1277 MELVILLE STREET (COMPLETE APPLICATION)
DE409236 - ZONE DD

DEVELOPMENT PERMIT STAFF COMMITTEE MEMBERS

EXECUTIVE SUMMARY

Fig.1: VIEW IMPACTS ON POINTE CLAIRE: PROPOSED TOWER (SUBJECT DE: 1277 Melville)

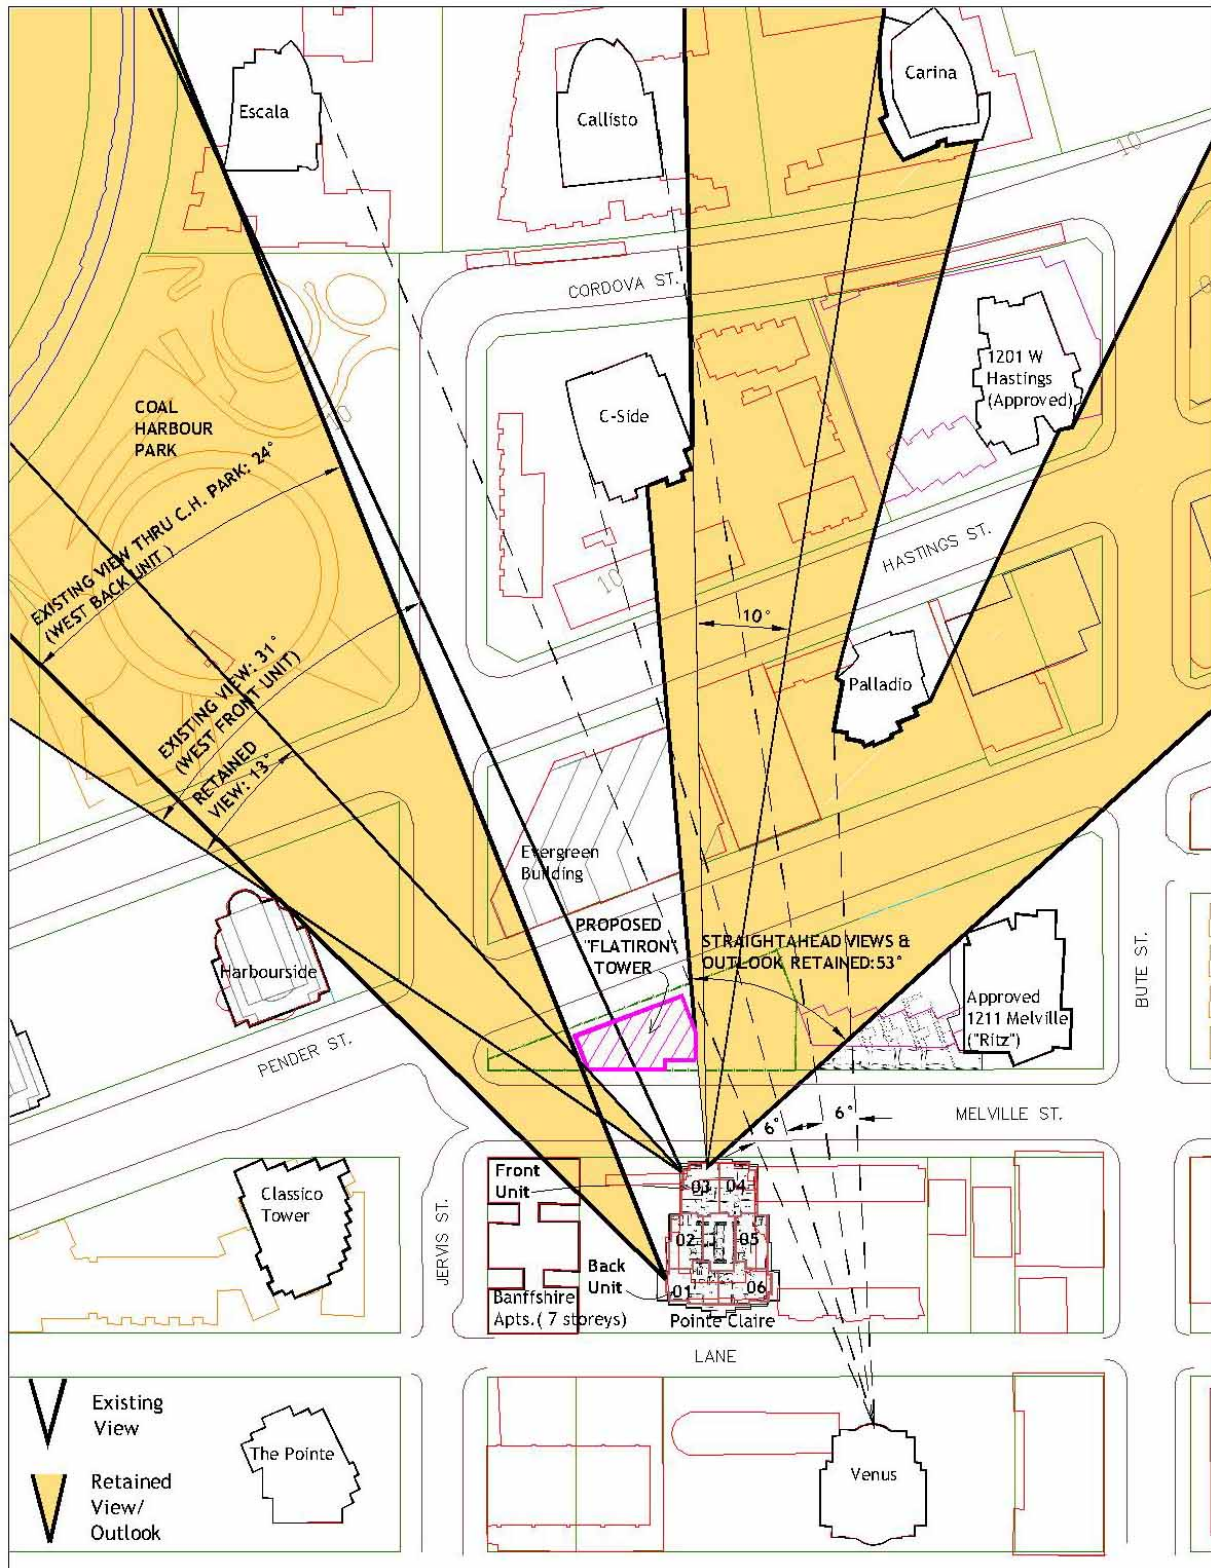
Private Views: The proposed tower, by shifting its location and setback another 6.4 m (21 ft.) further east (total setback from Jervis Street of 22.9 m [75 ft.]), will improve the views over Coal Harbour Park from the 70 west side units of the Pointe Claire (Refer to Fig. 1 & 3). In particular, the 26 West Front units would enjoy a 160% improvement over the previously approved/rejected scheme, an increase from 5 degrees to 13 degrees for this particular view (see Table 1). For the 24 West Mid and 22 Back units, improvements to the Coal Harbour Park view range are 64% and 33% respectively. The West Back units would retain 100% of their existing prime view over Coal Harbour Park. While the West Front units' view over Coal Harbour Park would be noticeably improved from 5 degrees to 13 degrees, they would lose a small portion of their Straight Ahead View (as a consequence of the proposed tower shifting east) above the Evergreen Building, although this view slot is at risk in any event because of the potential redevelopment of the Evergreen Building (refer to Fig. 1 & 3). For the East Front units, a slight improvement is achieved for their Coal Harbour Park View (gain of 3 degrees from zero), although, again, a small loss of Straight Ahead Views occurs. There would be no impact on existing views from the East Mid and East Back units. Table 1, below compares the view improvements for the west side and front units in the Pointe Claire. (Refer also to Appendix F: Applicant's Shadow & View Analysis, pages 3 to 11 and Appendix J: Comparison of Approved/Rejected [DE 408652 - 1280 W Pender Street] and Subject DE)

Conclusion (Private Views): While many west-facing Pointe Claire residents still prefer a significant relocation of the tower to the east side of the site, Staff conclude that the proposed tower location results in a considerable view improvement for them while avoiding a redistribution of impacts to other Pointe Claire units or other neighbouring buildings that would result from a further eastward shift of the tower. Staff, therefore, support the proposal.
